Meeting Agenda

Architectural Review Board

Certificate of Appropriateness

Case Number	COA2025-051
Hearing Date	December 16, 2025
Petitioner	Jonathan Nguyen
Property Location	831 South Peachtree Street
Current Zoning	OI (Office-Institutional)
Proposed Zoning	N/A
Proposed Structure	Storage Addition to an Existing Office Building
Character Area	Character Area 6: Buford Highway/Jimmy Carter Blvd Activity Center
Site Acreage	0.35 Acres
District	6
Land Lot	244
Parcel #	6244 138
Taxes Paid	N/A
Historic District	N/A

Description of Proposed Front Elevation:

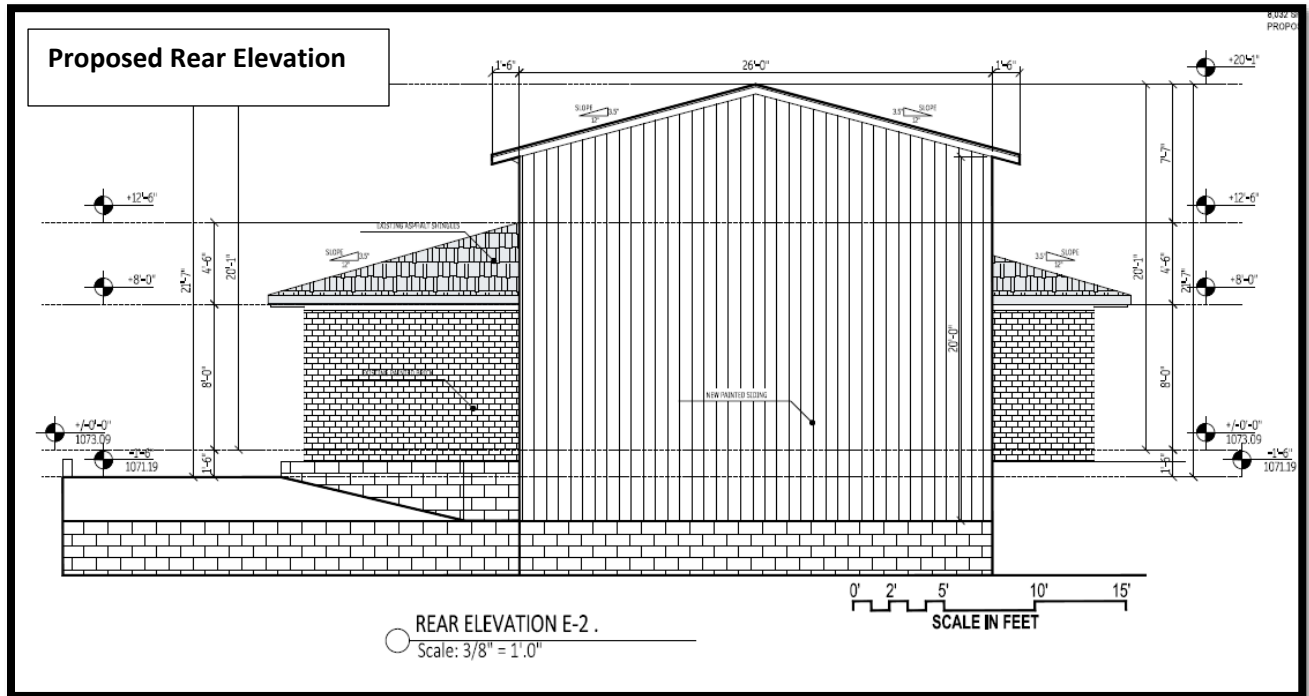
- The front façade of the rear addition will be visible from the right-of-way of South Peachtree Street, which has a proposed material of hardie-plank siding that will be painted gray to match the existing brick office building.

- Per Design Guideline 3.5.1.2, The façade of a building facing or visible from public right-of-way shall contain a combination of architectural treatments, windows, and doors such that the maximum allowable unbroken façade distance for each building or side of building visible from the right-of-way shall be 20 feet. Such controls shall pertain to both the vertical and horizontal elevations. All commercial buildings should have a distinguishable base and cornice for each level of the building.

- Should the addition be compatible to the existing office building in terms of scale, height, proportion, roof shape, material, style and color?

Description of Proposed Rear Elevation:

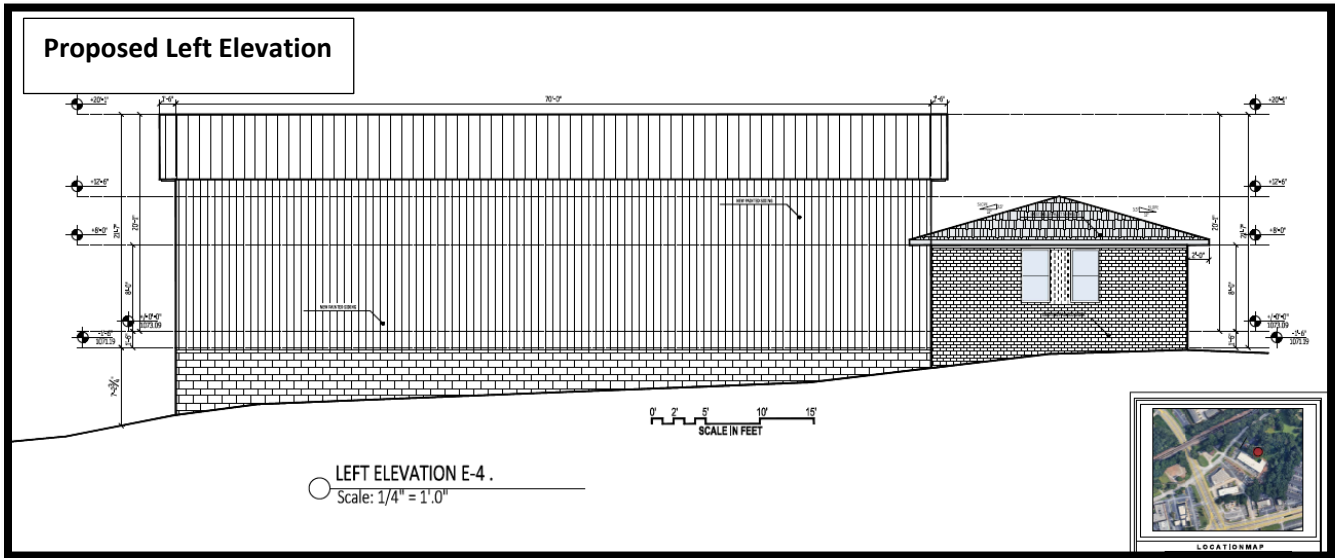
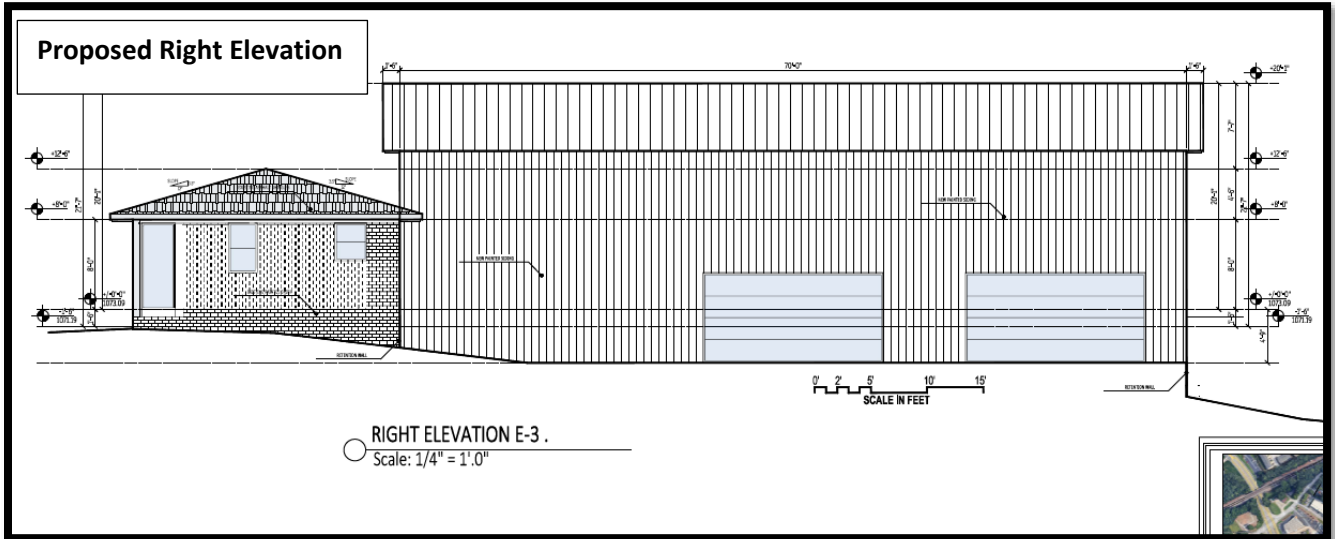
- The rear façade shows a proposed material of hardie-plank siding with a brick water table. According to the application, the hardie-plank siding will be painted gray to match the existing office building.

- Should the addition be compatible to the existing office building in terms of scale, height, proportion, roof shape, material, style and color?

Description of the Proposed Right Elevation:

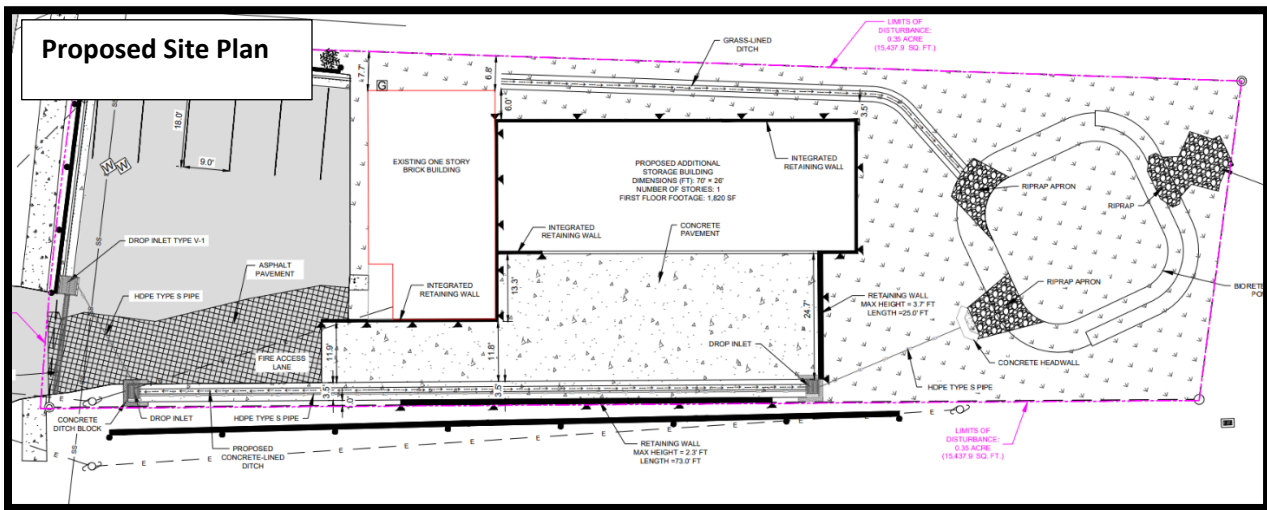
- The proposed right elevation shows hardie-plank siding which will be painted gray to match the existing office building. The right elevation shows two door (2) entry points into the storage building.
- **Discussion/Consideration Items:**
 - 1. Offer details about the materials being used for the storage doors on the right elevation; and
 - 2. Should a brick water table be added to the right elevation to match the proposed left and rear elevation?
 - Should the addition be compatible to the existing office building in terms of scale, height, proportion, roof shape, material, style, and color?

Description of the Proposed Left Elevation:

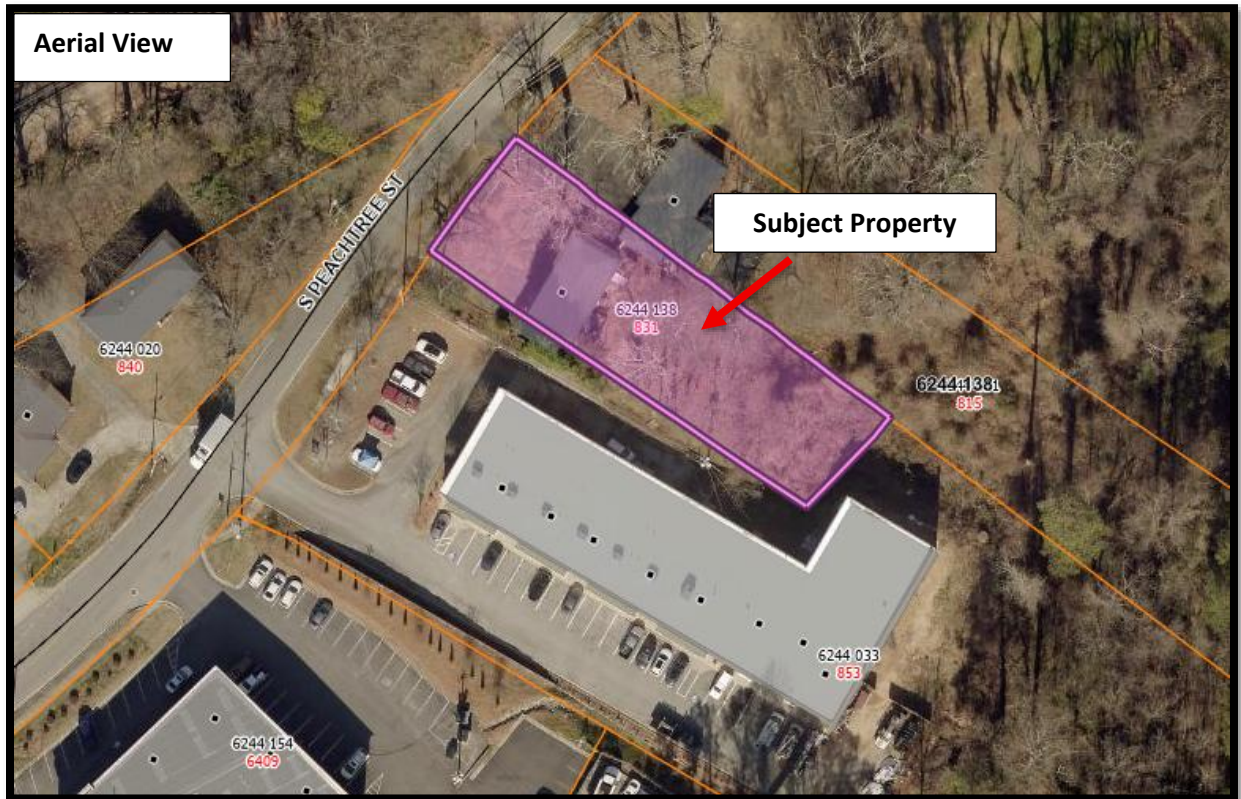
- The proposed left elevation shows hardie-plank siding which will be painted gray to match the existing office building. There is also a brick water table shown.
- **Discussion/Consideration Items:**
 - 1. Should the blank façade offer some kind of fenestration?
 - Should the addition be compatible to the existing office building in terms of scale, height, proportion, roof shape, material, style and color?
